ADDENDUM 1

DATE: June 21, 2019

Contract 19-C-00034; Saint Isabel Pumping Station Rehabilitation

SHEET
7

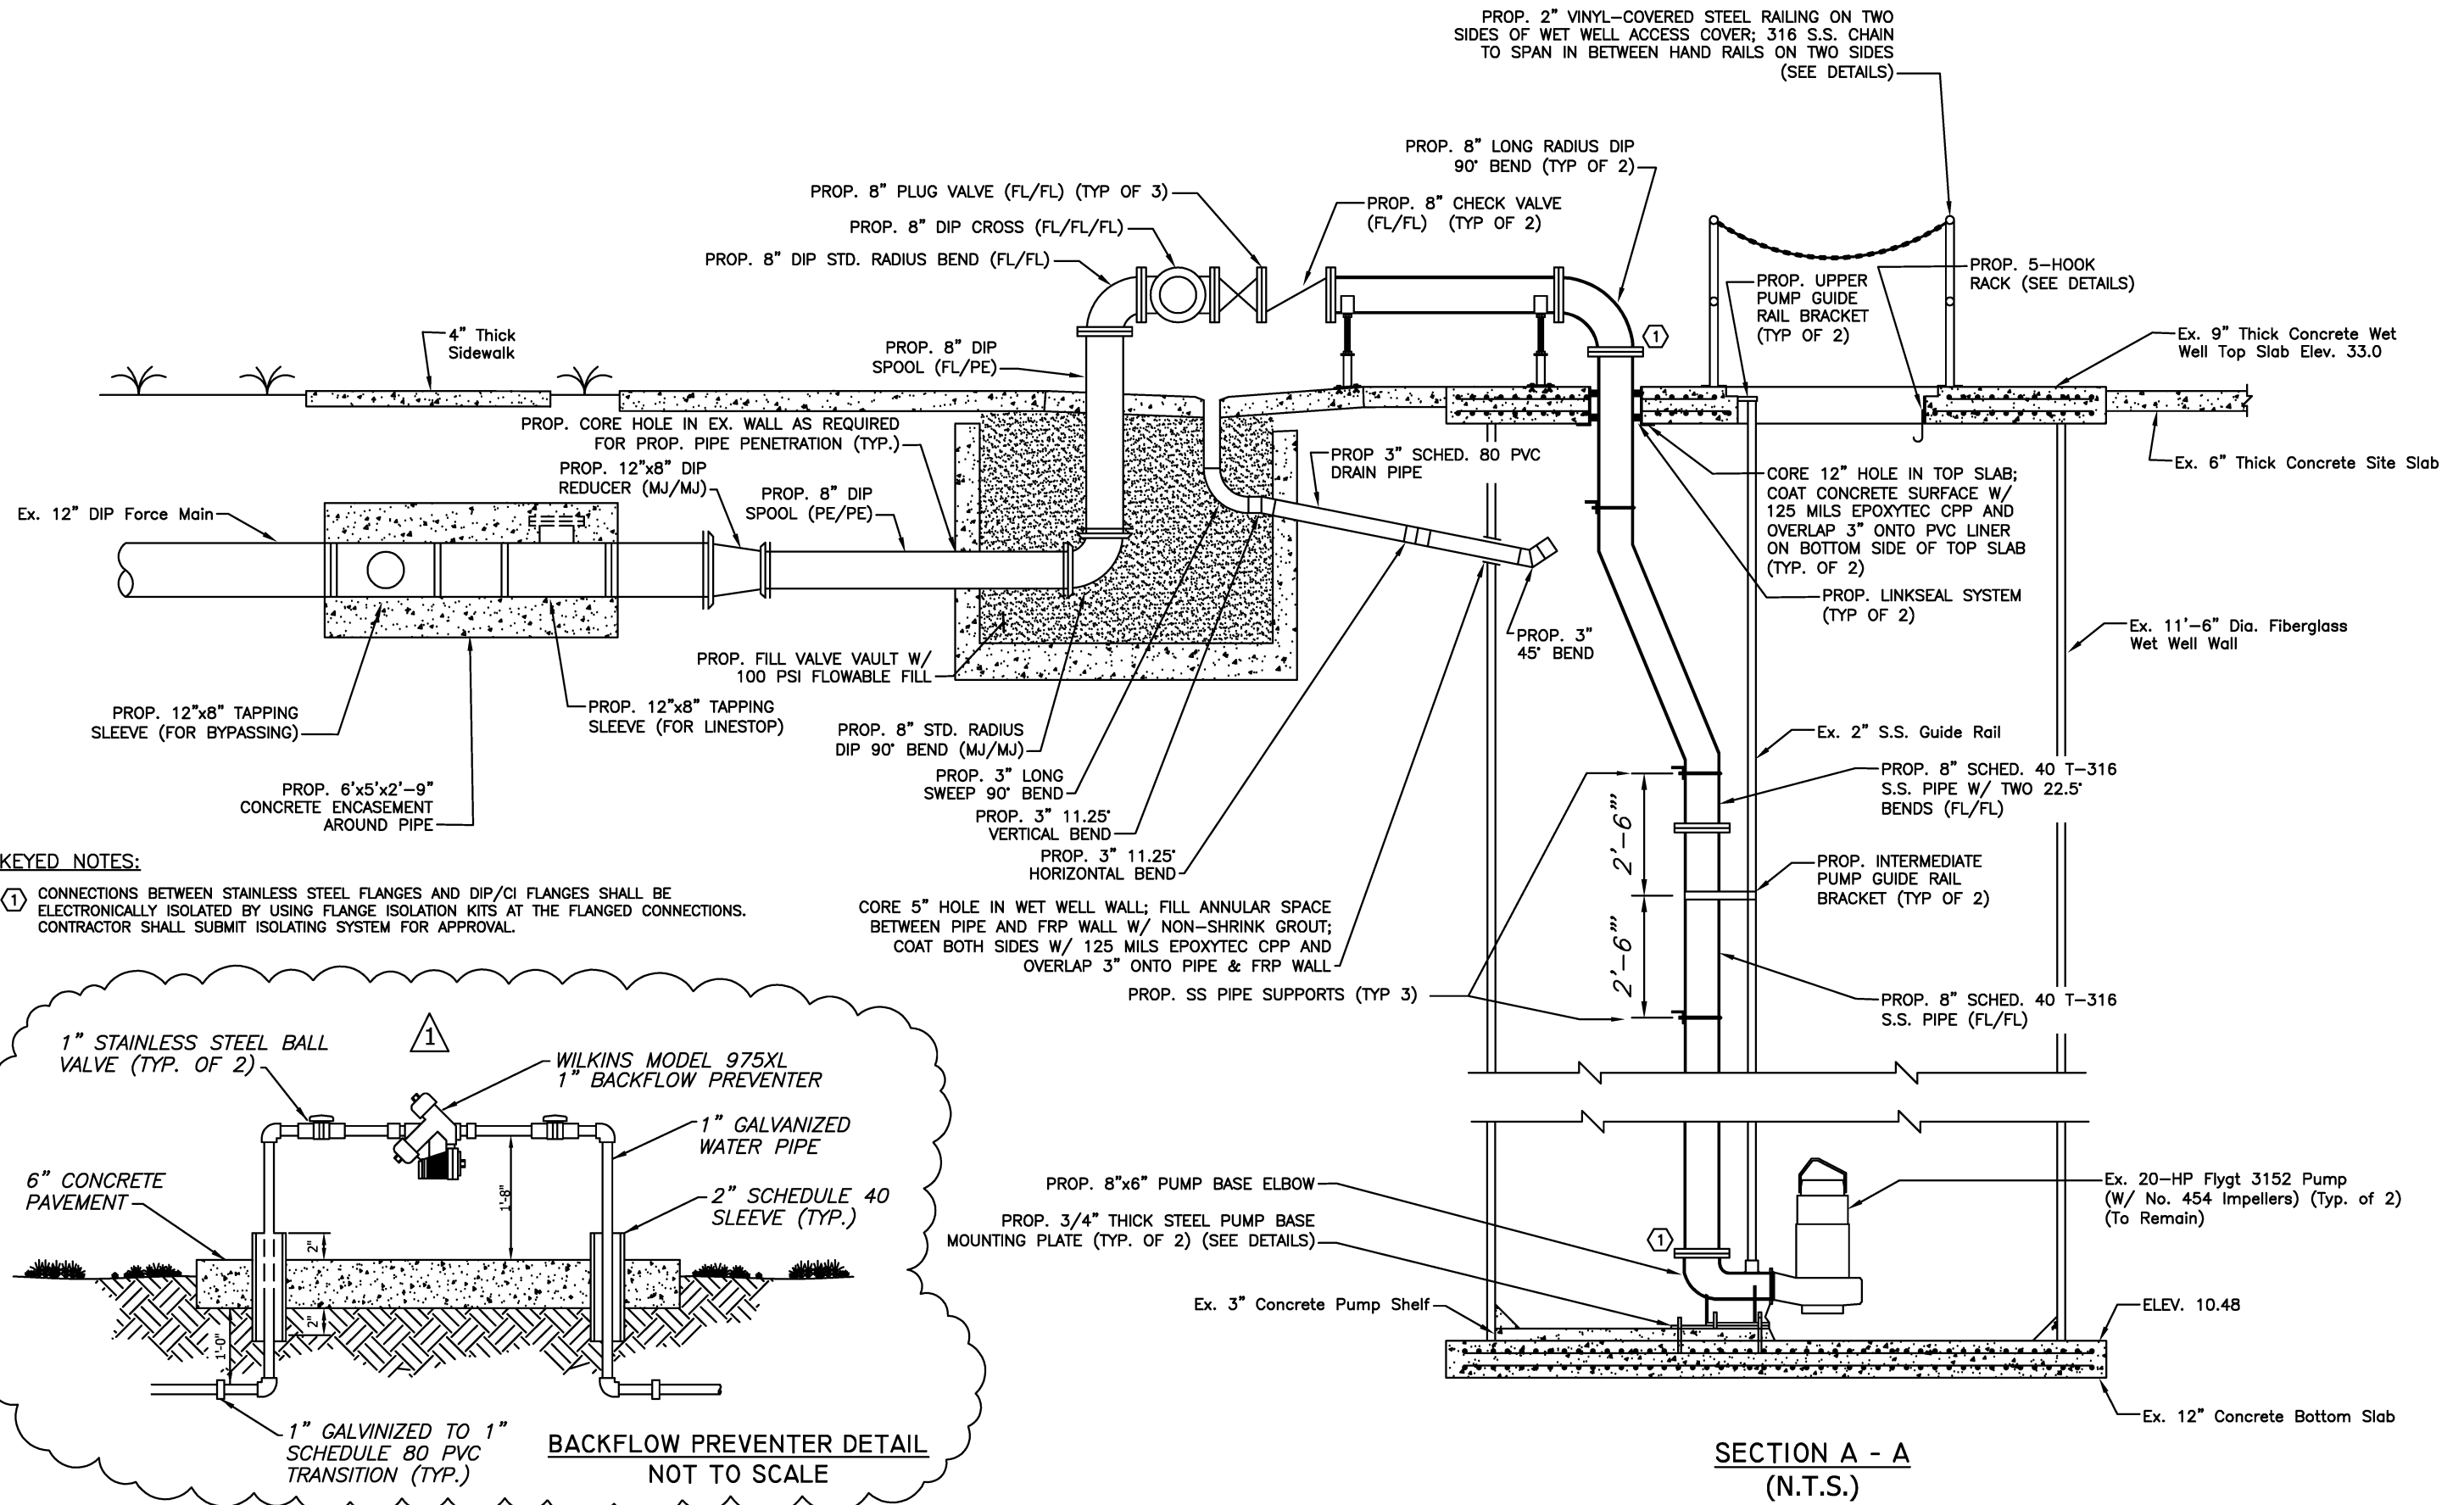
Item 2: Replace Plan Sheet 7 of the with the attached revised Sheet 7.

No.	DATE	REVISIONS
3		
2		
1	6/18/19	Added Backflow Preventer Detail

BACKFLOW PREVENTER DETAIL
NOT TO SCALE
